SUBJECT: Forwards revised responses to NRC Questions 440.1 through 440.87. Responses will be incorporated into future FSAR amend.

Subject: Palo Verde Nuclear Generating Station
(PVNGS) Units 1, 2 and 3
Docket Nos. STN-50-528/529/530
File: 81-056-026; G.1.10

Attached are revised responses to NRC Questions 440.1 through 440.87, for your use. These responses will be incorporated into the FSAR in an upcoming amendment.

Palo Verde Nuclear Generating Station FSAR
RECIRCULATION SUMPS CONTAINMENT BLDG. EL. 80'	
Figure 6A-4

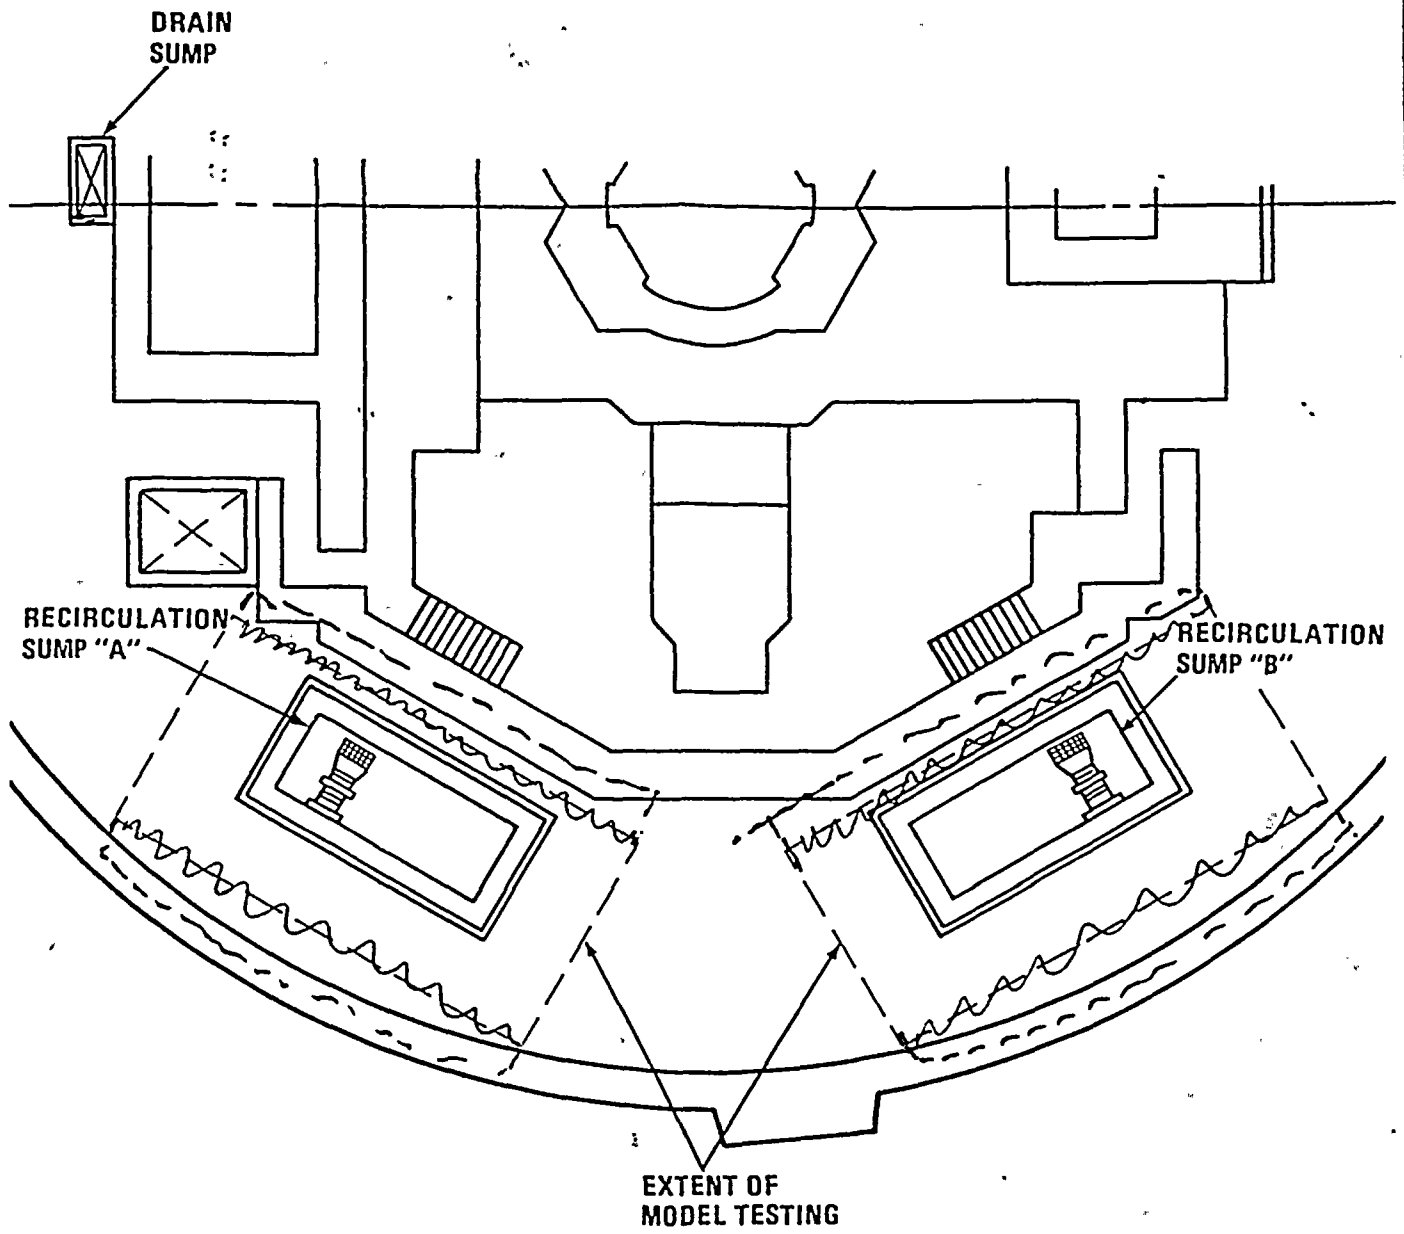
← 5.2 Figure 6A-4 shows the location of the drain sump
 relative to the containment sump.

Figure 6A-5

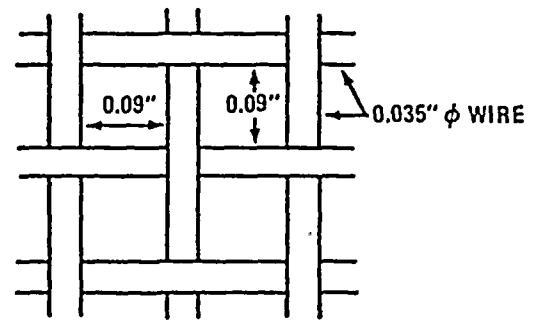
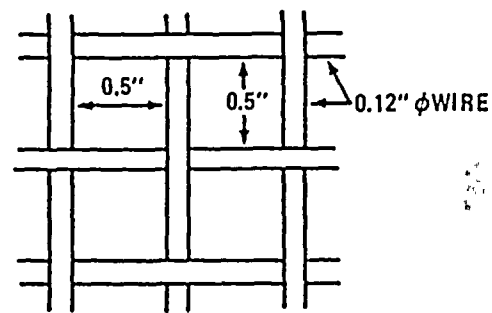
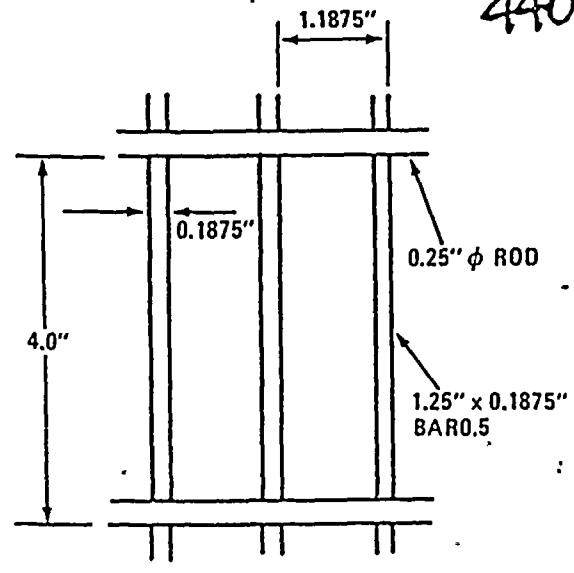
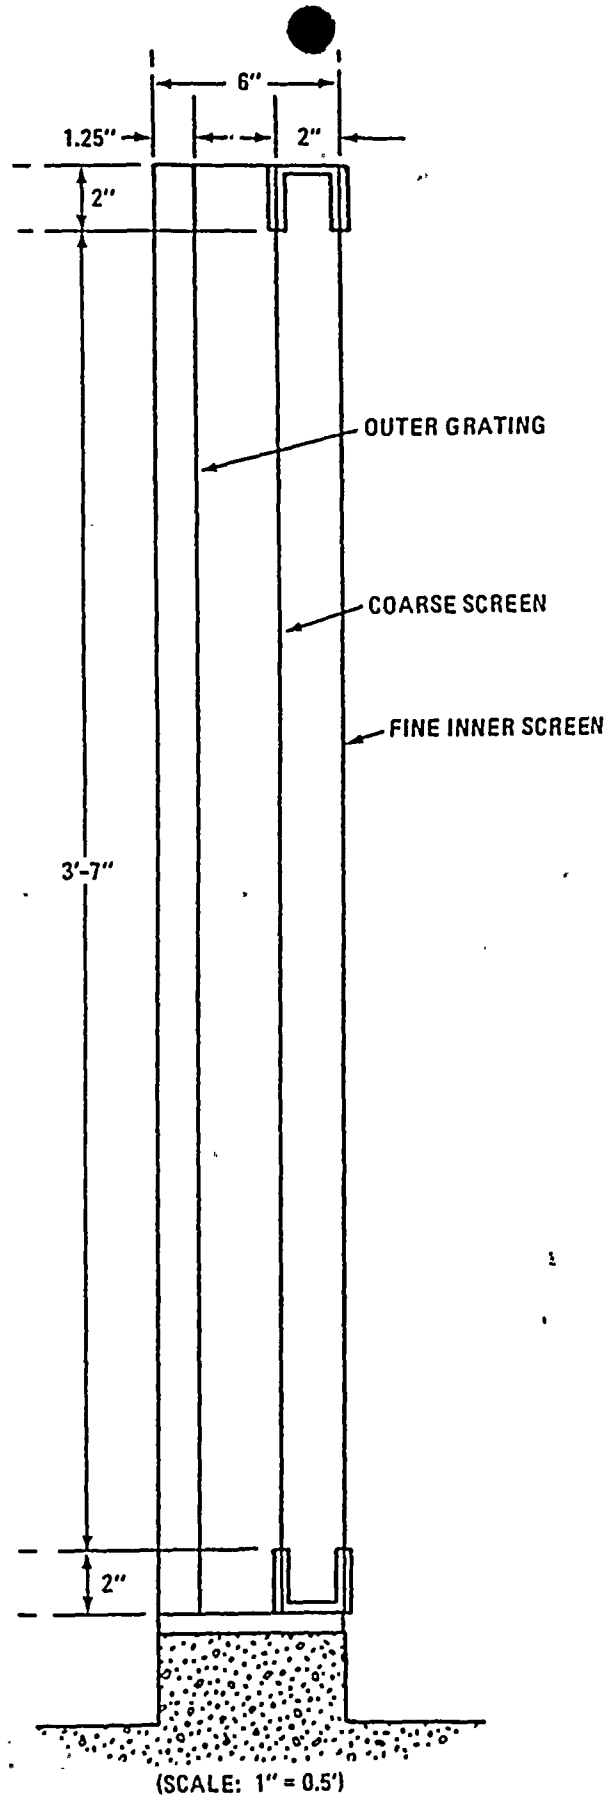
5.3.a. Figure 6A-5 provides the size of openings on the
 screens. No flow blockage will occur beyond the screen as
 all openings are larger than the minimum screen size.
